**THE CAMBOURNE TO CAMBRIDGE ORDER**

**REBUTTALS - APPENDICES**

# **Cambourne to Cambridge (CtoC) Scheme**

Further Assessment of CPPF Alternative Scheme

**Figure 3-2 - Extents of Section C**

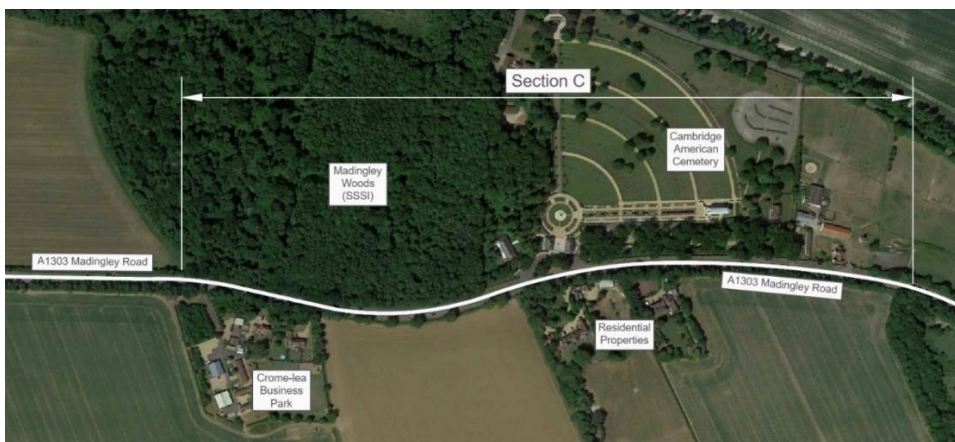
- 3.1.3. The primary focus is on the proposed inbound bus lane through the most constrained part of the site—**Section C** (see Figure 3-2). This area includes sensitive locations such as **Madingley Woods (SSSI)** and the **American Cemetery and Memorial** to the north, as well as several commercial and residential properties to the south.

DRAWING TITLE: Proposed General Arrangement Plan Sheet 1 of 3

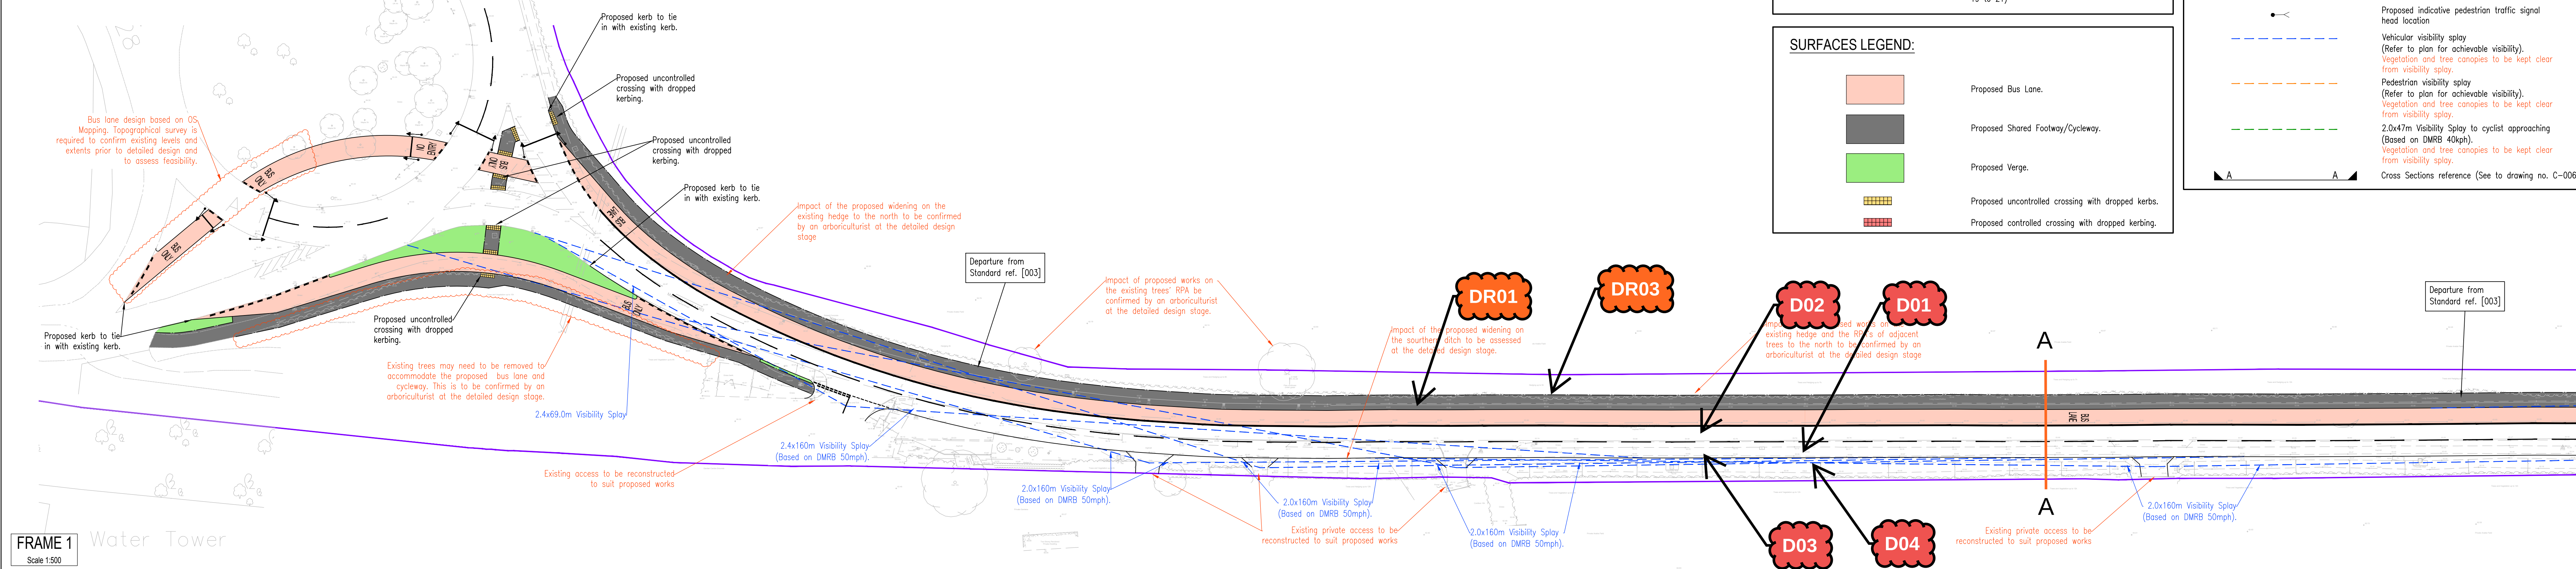
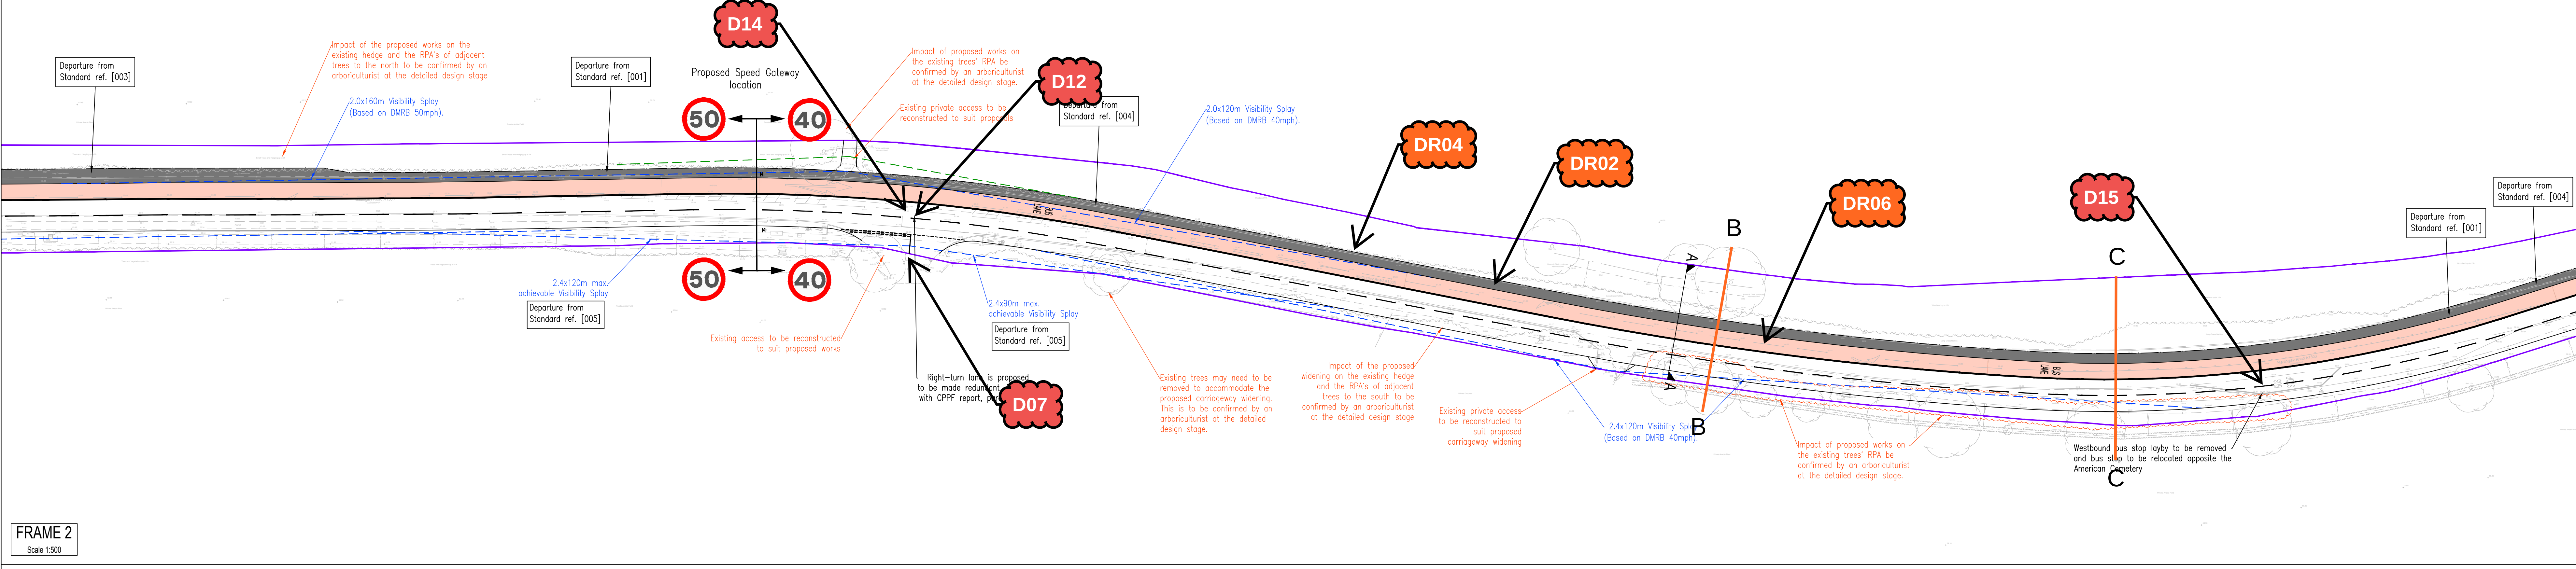
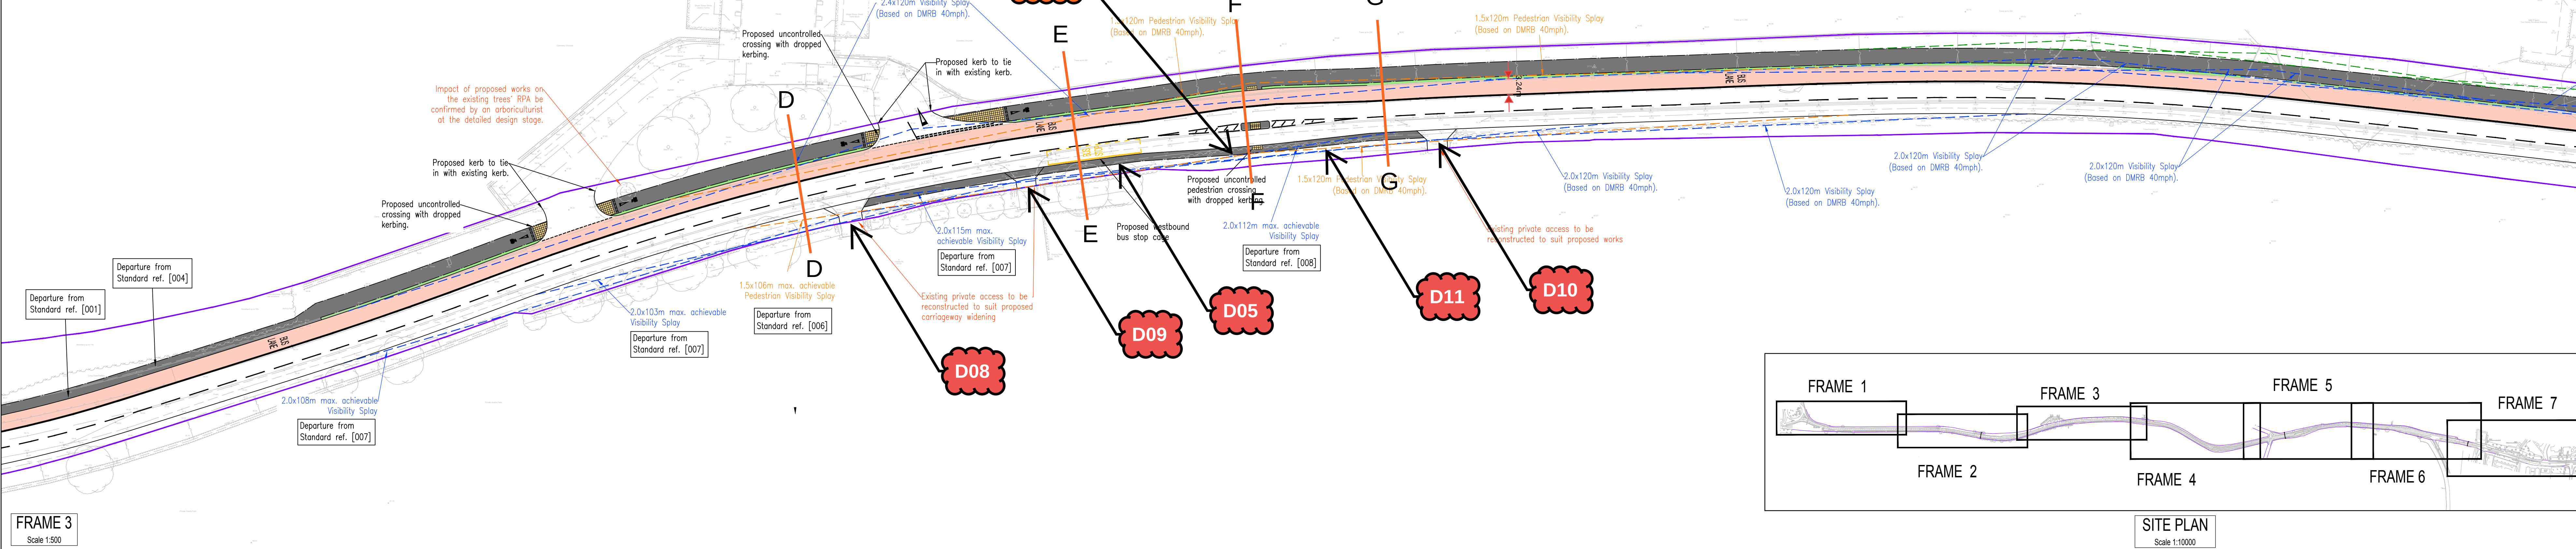
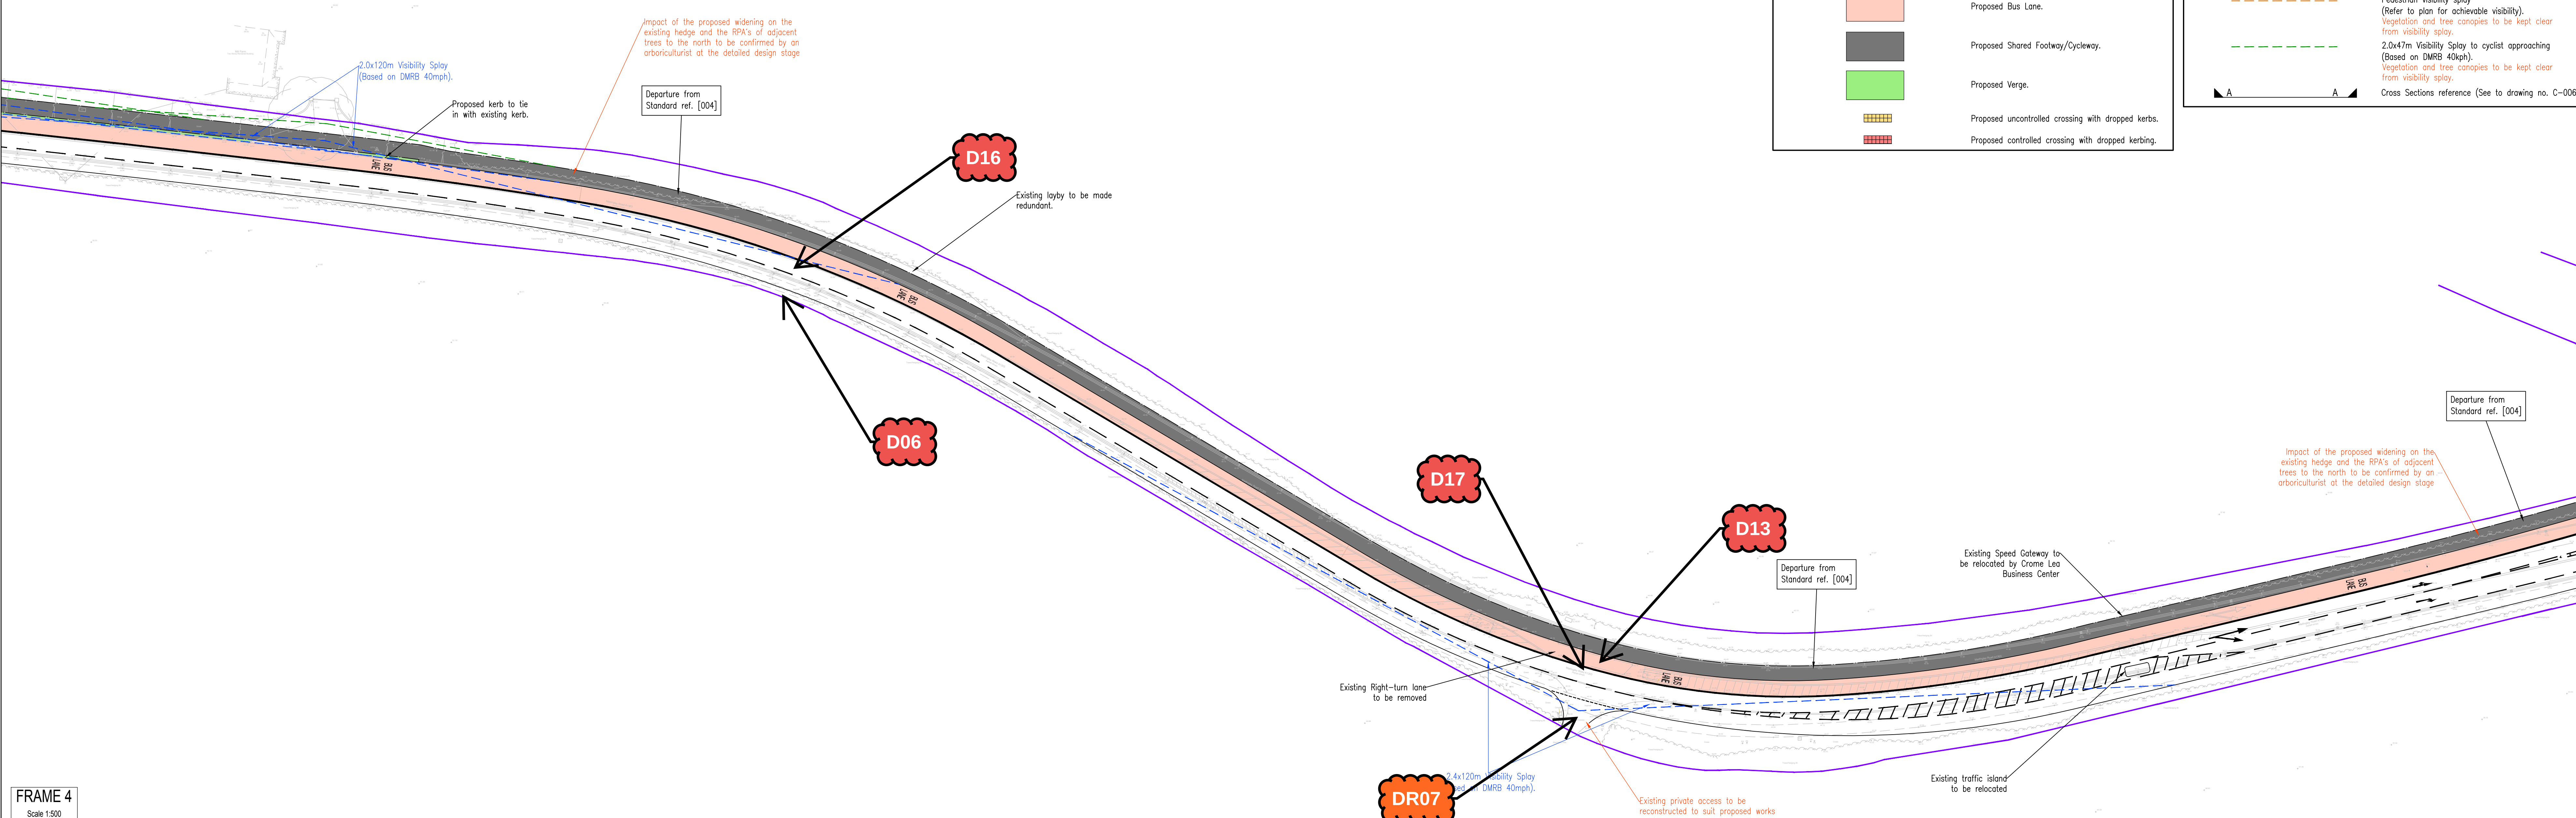
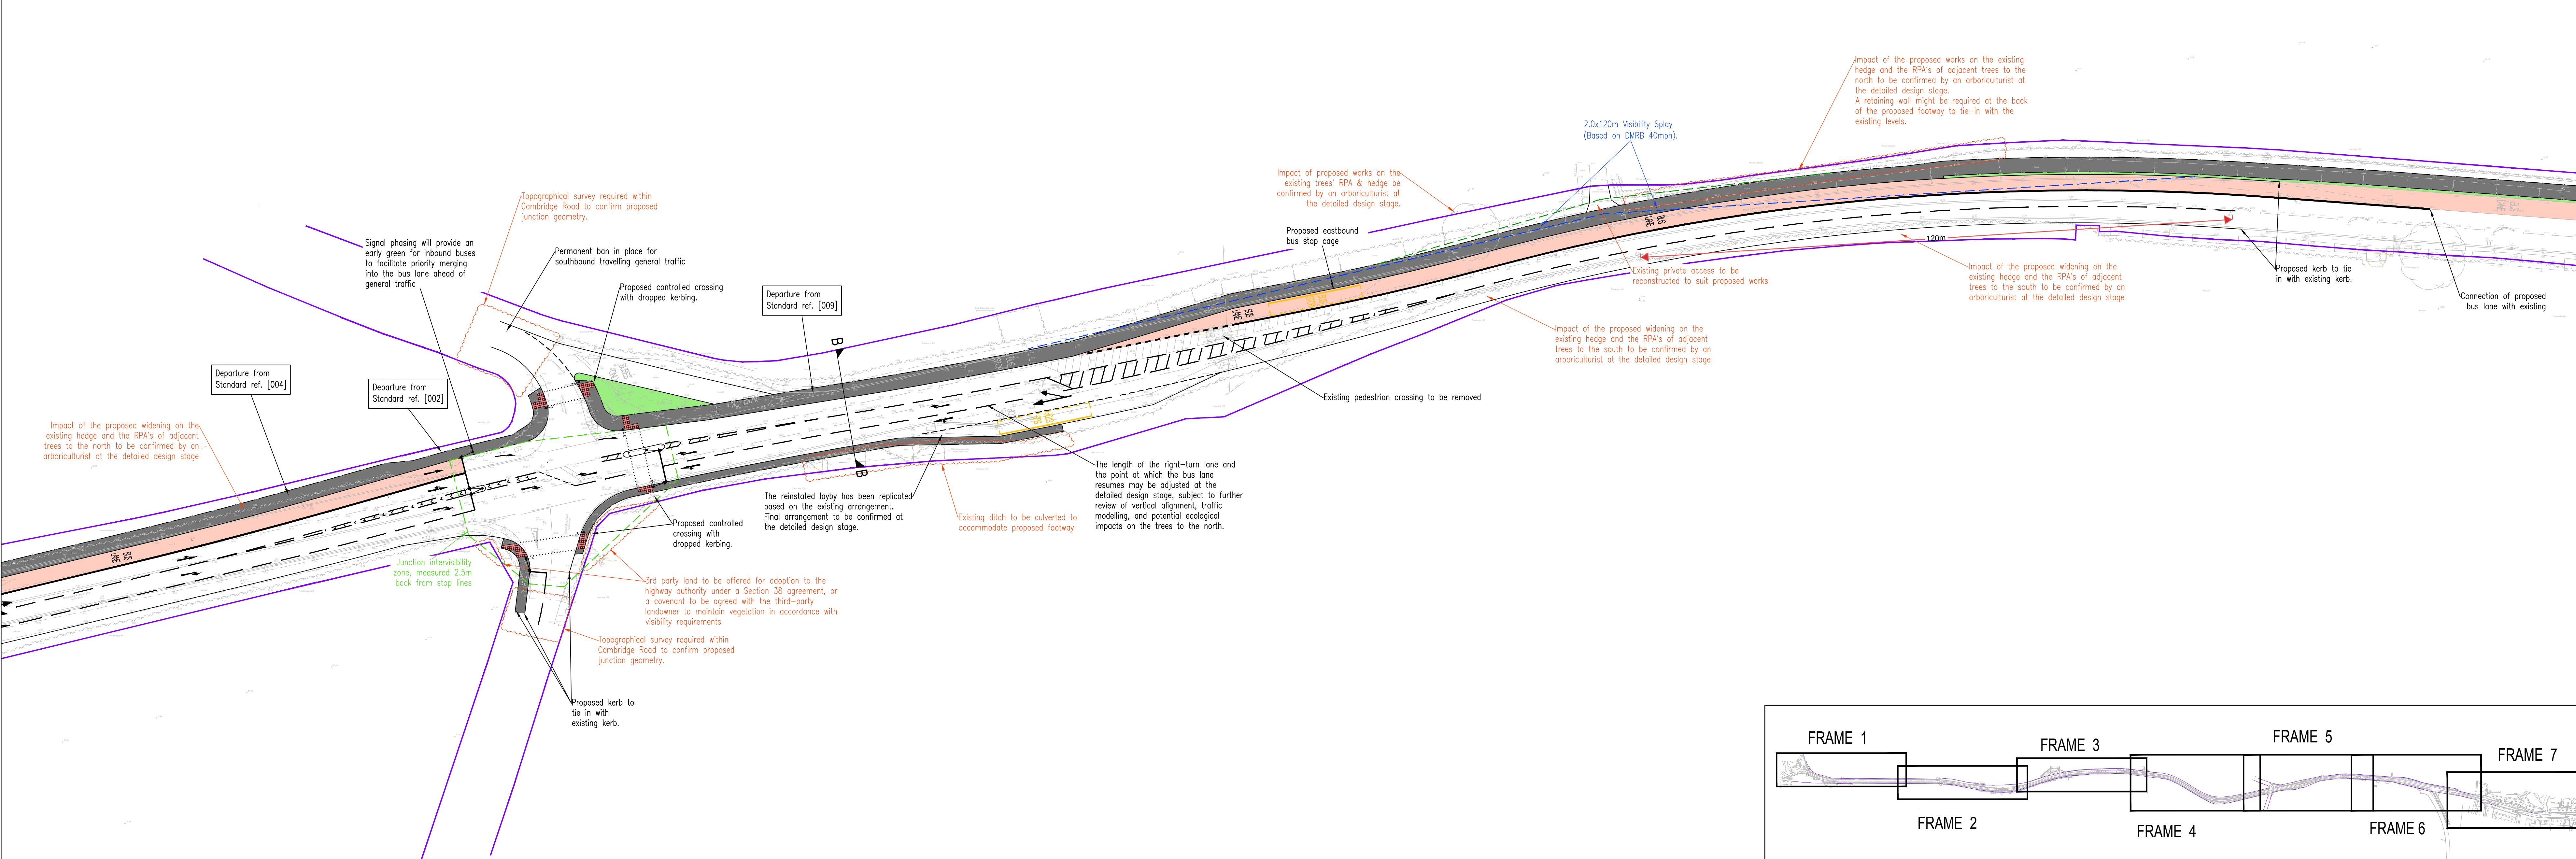
Existing ditch re-provided - not shown on CPPF Plans

1 in 3 slope not shown on CPPF Plans

Standard verge not shown on CPPF Plans

1 in 3 slope not shown on CPPF Plans
